LTR-CDME-08-43 NP-Attachment

Response to NRC Request for Additional Information Relating to
LTR-CDME-08-11 NP-Attachment

QUESTIONS RELATING TO STEAM GENERATOR TUBESHEET AMENDMENT ON INTERIM ALTERNATE REPAIR CRITERIA

Figure 11-3: Tube Crack Geometry

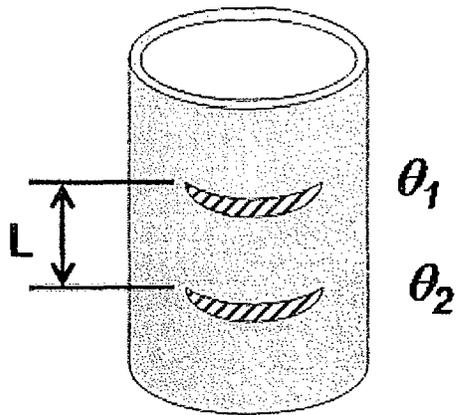
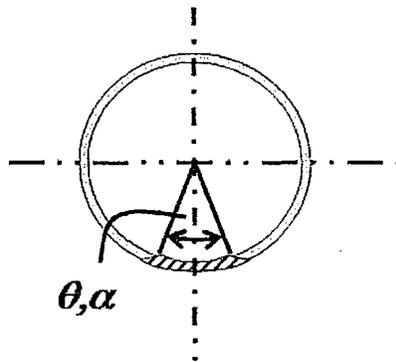
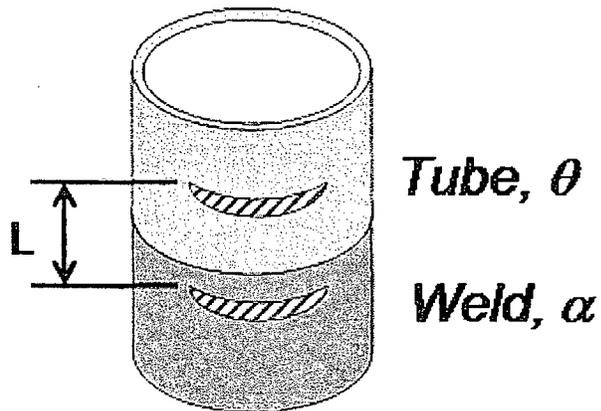
11. The proposed tube and weld repair criteria do not address interaction effects of multiple circumferential flaws which may be in close proximity (e.g., axial separation of one or two tube diameters). Address this concern and identify any revisions which may be needed to the alternate tube repair criteria and the maximum acceptable weld flaw size.

The impact of the crack separation analysis is summarized below. Refer to Figures 11-3 through 11-5 for explanations of the crack geometries and combinations of crack-like indications considered in the analysis. Table 11-1 is a summary of the text description of the crack separation analysis impacts. The details described in Table 11-1 apply only to the portion of the tube within the tubesheet 17 inches below the top of the tubesheet (TTS-17 inches).

1. If any circumferential crack-like indication in the tube exceeds 203°, plug the tube.
2. If there is more than one circumferential crack-like indication in a tube, and no single crack angle exceeds 203°, and the minimum axial distance of separation between the crack-like indications is

3. If there is more than one circumferential crack-like indication in a tube, and no single crack angle exceeds 203° , and the minimum axial distance of separation between the crack-like indications is less than 1.00 inch, and the non-overlapping sum of the crack angles plus the overlapped crack angle is less than or equal to 203° , the tube may remain in service.
4. If there is more than one circumferential crack-like indication in a tube, and no single crack angle exceeds 203° , and the minimum axial distance of separation between the crack-like indications is less than 1.00 inch, and the non-overlapping sum of the crack angles plus the overlapped crack angle is greater than 203° , plug the tube.

5. If there are one or more cracks in the tube that are each less than or equal to 94° , and there is a minimum axial separation distance between the tube end and the tube cracks of less than 1.00 inch, and the non-overlapping sum of the tube crack angles plus the overlapped crack angle is less than or equal to 94° , the tube may remain in service.
6. If there is a crack-like indication in the weld less than or equal to 94° and there are one or more cracks in the tube that are each less than or equal to 94° , and there is a minimum axial separation distance between the tube end and the tube cracks of less than 1.00 inch, and the non-overlapping sum of the tube crack angles plus the overlapped crack angle is greater than 94° , plug the tube.
